**PERSIMMON HOMES THAMES VALLEY
LAND NORTH OF TODDINGTON LANE,
LITTLEHAMPTON**

**DRAINAGE STRATEGY, WEST OF
WETLANDS
(DISCHARGE OF CONDITION 10)**

Project Code:	A/PHDRAIN.10
Prepared by:	SF
Approved by:	AB
Issue Date:	24th January 2019
Status:	1st Issue

Image below: Shows the locations of the permeable sub-base within the Windes model..

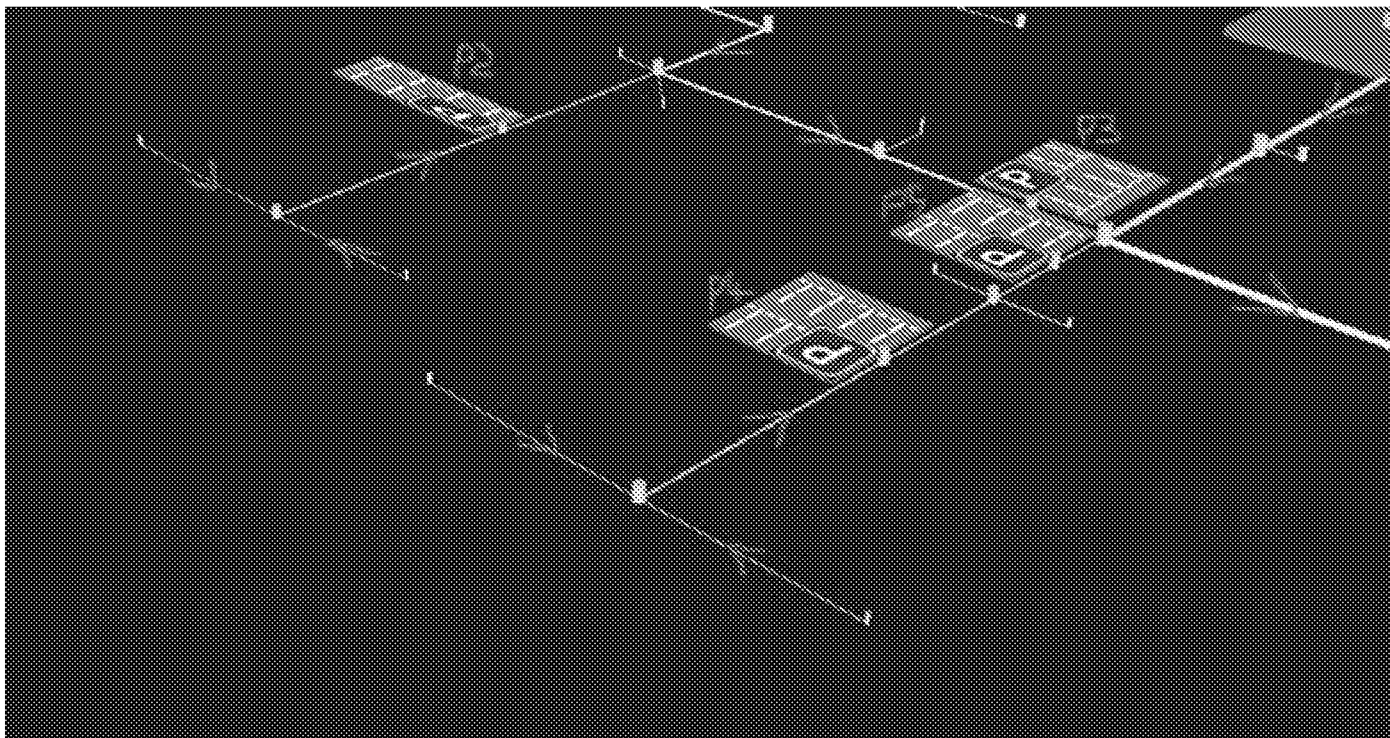
Whilst reading the response below please note we have updated our Windes model so it now includes the permeable sub-base. See image below where we've added new nodes and modelled is as a "porous car park" (function within the programme) where the storage within 30% voids of the granular sub-base is recognised. We have distributed it as evenly as possible across the areas where the granular sub-base is located. The addition improves the results significantly and the total flooding volume for the fully surcharged critical 1in100yr+CC storm is now only 35m3 (spread across 4 different locations) that can safely be contained within the site.
